**SYDNEY CENTRAL CITY PLANNING PANEL
COUNCIL ASSESSMENT REPORT**

Panel Reference	2018SWC055
DA Number	DA/613/2016/E
LGA	City of Parramatta
Proposed Development	Section 4.55(1A) modification to an approved mixed use development. Modifications include the reduction of 3 apartments, reconfiguration of parking areas, signage, awnings and apartments, staged occupation and the provision of 2 additional retail tenancies.
Street Address	14 Burroway Road, Wentworth Point (Lot 11 DP270778)
Applicant	Fairmead Business Pty Limited
Owner	Fairmead Business Pty Limited
Date of DA lodgement	18 December 2017
Number of Submissions	None – Notification not required.
Recommendation	Approval subject to revised conditions
Regional Development Criteria (Schedule 4A of the EP&A Act)	Pursuant to Schedule 7 of State Environmental Planning Policy (State and Regional Development) 2011, the proposal is a s4.55(1A) modification to an application with a capital investment value of more than \$30 million.

Figure 3: Section of revised retail car park levels

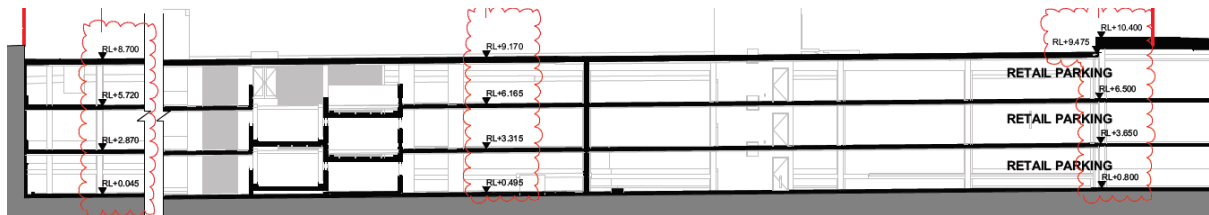
The revision of the retail car park levels allows the above public open space to achieve an on-grade transition from the adjoining public domain footpaths. Additional excavation to RL +0.045m AHD in the retail basement would extend below the water table as measured in the original Geotechnical report (Doc. No 72264.07 Draft 0), 11 December 2014, prepared by Douglas Partners. This would then require referral to DPI – Water to determine if a dewatering licence must be obtained. However, in response the applicant's geotechnical consultant has provided an addendum groundwater advisory letter stating this is not necessary, for the following reasons:

- Current on-site piling excavations undertaken by the proponent to depth of -0.25m AHD, have not encountered the water table to date and that dewatering was not needed throughout any prior excavation works.
- This on-site data has revealed that the ground water level is currently lower than the borehole measurements conducted in 2014 ranging from +0.8m to +1.2m AHD.
- The additional 755mm of partial excavation, is relatively minor and would not require a dewatering licence as the basement is to be fully tanked to RL +1.6m AHD.

On the basis of the consultant's recommendations a new consent condition will be inserted to secure basement tanking specifications and protect these underground levels from the water table, as detailed below:

104.A *The retail basement is to be fully tanked to RL +1.6m AHD. Details of compliance are to be submitted the PCA prior to the issue of the relevant occupation certificate and or any use of this parking area.*

Figure 4: Three Phase Occupation Diagram

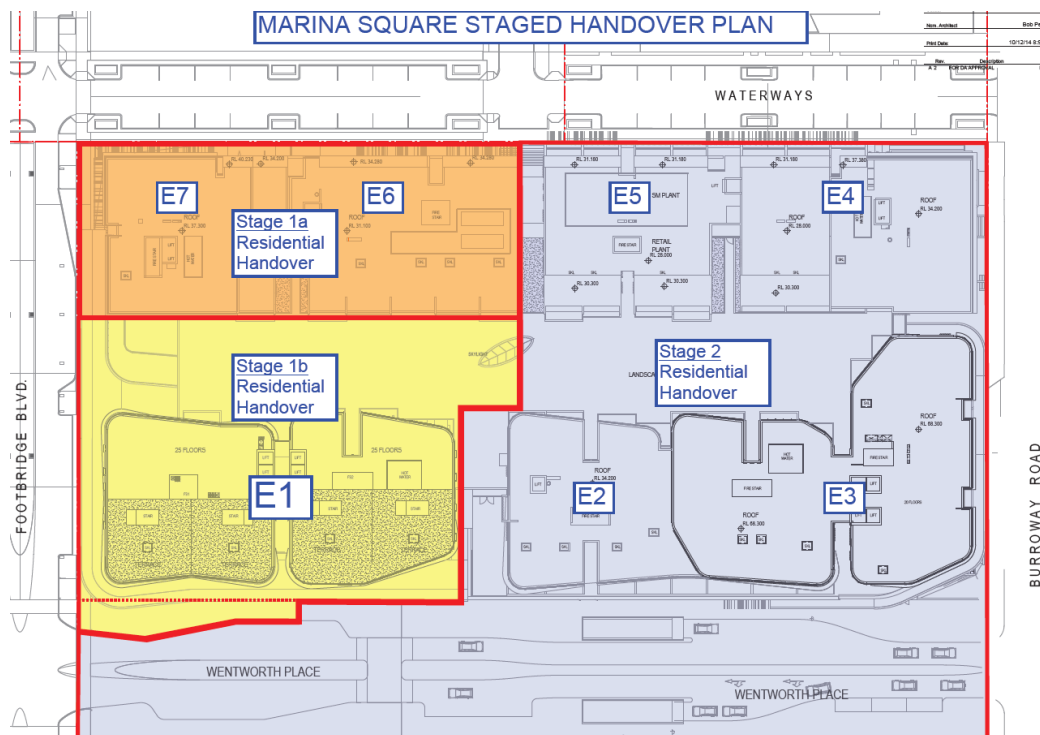
It is proposed to stage the occupation of the residential towers, so that safe access can still be provided whilst construction of the retail car park to the southeast and the Wentworth Place road are finalised.

- **Stage 1A:** Occupation of residential apartments accessed from circulation cores E6 and E7, which adjoin Waterways Street.
- **Stage 1B:** Occupation of residential apartments accessed from circulation core E1 with direct access provided to Footbridge Blvd.
- **Stage 2:** Occupation of retail tenancies, residential apartments accessed from circulation cores E2 – E5 and the retail car park after the completion of Wentworth Place road works.

Furthermore, the issue of interim occupation certificates would not conflict with pedestrian access to the nominated residential lobbies, waste management procedures, residential parking spaces, services or general accessibility.

Council can support the interim occupation of these residential areas, subject to the inclusion of references that secure the necessary support services and amenities prior to the issue of the relevant occupation certificate. Condition 107, 108, 109 and 149 have been amended in the concluding recommendation accordingly.
